Staff Report

Subdivision Case#SDF2013-8-3

Final approval of Thames Subdivision (Lots 2A, 3A, 4A, & 5A), acceptance of dedication of all public improvements, acceptance of dedication of the extension of West Robert St (60' x 100.05' right of way), acceptance of performance bond/letter of credit for the construction of all public improvements located at 1010 W. Robert St. in accordance with amended final plat by Andrew N. Faller and construction plans by Duplantis Design Group; Zoned R11 & Hyer Cate Overlay (SDF2013-8-3) recommended approval w/conditions by Planning Commission

AMENDED FINAL PLAT
THAMES SUBDIVISION
PORTIONS OF SQUARES 155 & 156
CATE ADDITION
CITY OF HAMMOND
SECTION 26, T6S-R7E
GREENSBURG LAND DISTRICT
TANGIPAHOA PARISH, LOUISIANA

UTILITY SITE PLAN

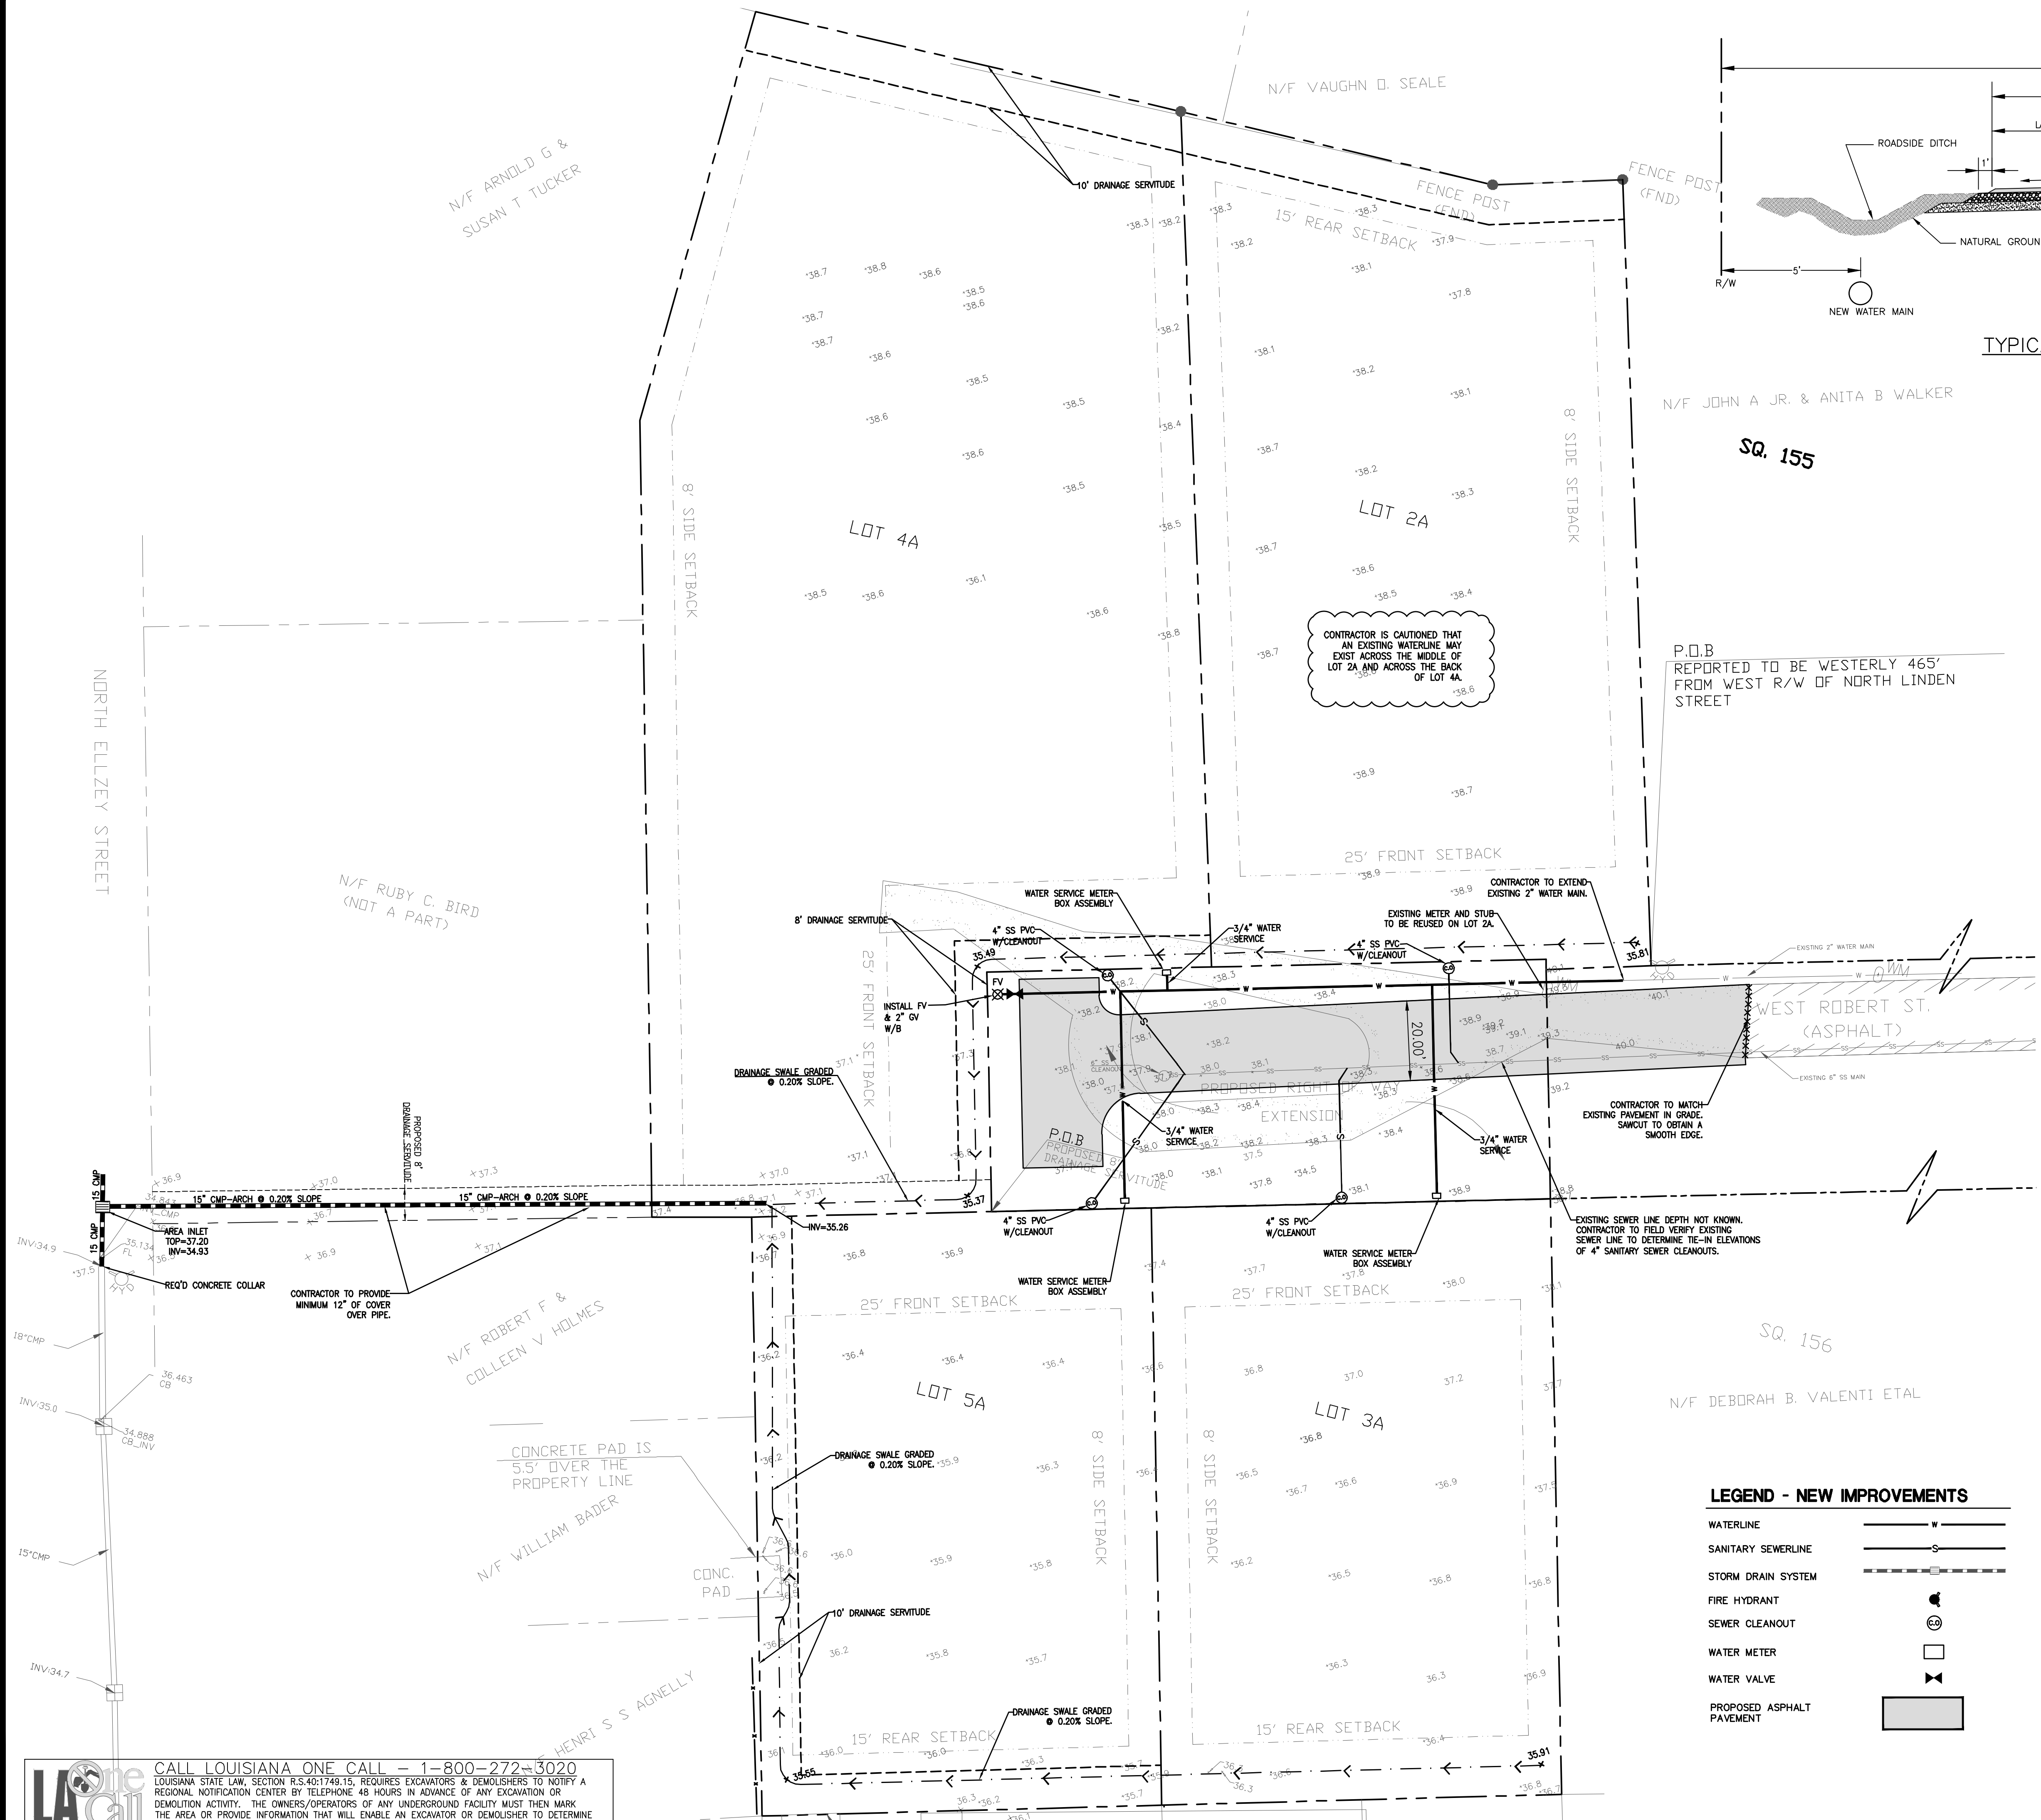
1. Out fall drainage to Ellezy may have two large trees to be mitigated.
2. Out fall drainage is 12" (too small)
3. Out fall drainage needs more catch basins
4. Need to know if drainage along Ellezy is adequate
5. No drainage showed for front of lots
6. Need street build plans
7. Street lights??

Tracie, any culverts with exposed openings will have to be asphalt coated or concrete. All other types must have a protected head wall. I think that additional catch basins on the out fall drainage is necessary.

1. Plans show connecting to a 4" existing water main on Robert Street, the main on Robert Street is only 2" from Linden Street west to site of proposed subdivision.
2. There is a 2" line crossing this property to Ellzey Street that will need to be rerouted.

We are aware of the 2 water oaks that will need to be removed.

If 12" is too small for the outfall drainage, what is required?

What are the City requirements on catch basins? I thought we were originally proposing 3, but it looks like on the plan they only show the one where we tie into the City on Ellzey.

Are you asking me if the drainage on Ellzey is adequate?

No drainage on front of lots because the elevations show Lot 2A, 3A, & 5A all flow to the backs of the property. A small portion of Lot 4A flows to the road which will go toward the new drainage servitude/catch basin.

I will have to ask on the street build plans.

I believe the existing Entergy pole has a street light and I think that should be adequate.

"There is a 2 inch line crossing this property to Ellzey Street that will need to be re-routed. To date, no one can tell me where this line actually is. In addition, it is through private property that is not part of the right of way. What purpose does it serve and why does it need to be rerouted? And if it needs to be rerouted, where to? There is no existing servitude for this water line. I am not sure why I have to reroute a City line?
